Access Compliance Report

Public Rights-of-Way

Intersection ID: 27384	Main Street: DOVEHUNT_PL	Cross Street: VALLEY_SPRING_DR	Location:	N
ADA ID: B01C43F9B1EB	Ramp Type: PerpDiag	Initial Pass/Fail: Fail	Overall Compliance: No	Severity Score: 25

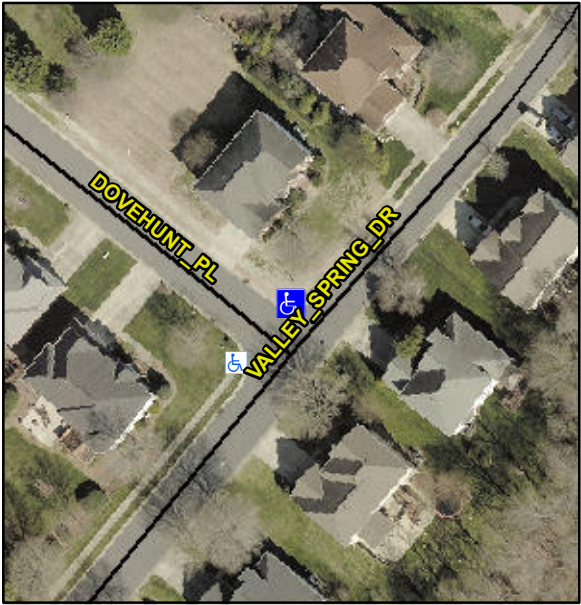
Codes/Mitigation Info/Possible Solution			Field Measurements/Component Compliance		
	Possible Solutions:		Compliance	Description	Data
	Remove & Replace Curb Ramp With Two New Directional Ramps or Equivalent.		N/A	Ramp Length (in)	46.0
			Yes	Ramp Width (in)	48.0
			N/A	Flare Type LT	N/A
			N/A	Flare Slope LT (%)	N/A
			N/A	Flare Traversable LT?	N/A
			N/A	Landing Length (in)	N/A
			N/A	Landing Width (in)	N/A
			N/A	Landing Slope (%)	N/A
			N/A	Landing X Slope (%)	N/A
Surveyor Notes: N/A PROW/ADA: Not Found, R304.5.3			N/A	Flare Type RT	N/A
			N/A	Flare Slope RT (%)	N/A
			N/A	Flare Traversable RT?	N/A
			N/A	DWS Provided?	N/A
			N/A	DWS Contrast?	N/A
			N/A	DWS Length (in)	N/A
			N/A	DWS Full Width?	N/A
			N/A	DWS Offset (in)	N/A
			N/A	Shared Landing?	N/A
			N/A	Gutter Ponding?	N/A
			N/A	Gutter Lip Ht (in)	N/A
			N/A	Painted X Walk1?	No
				X Walk 1 Direction	To SW
			N/A	X Walk 1 Width (in)	N/A
				X Walk 1 Slope (%)	8.6

X Walk 1 X Slope (%)	4.0
			N/A	Ramp inside XWalk1?	N/A
				Road Slope (%)	9.2
				Road X Slope (%)	1.4
			N/A	Any Obstructions?	N/A
				Obstruction Type	
Total Cost:		\$ 3200.00			
			N/A		N/A
			Yes	Surface Condition? (G/P)	Good
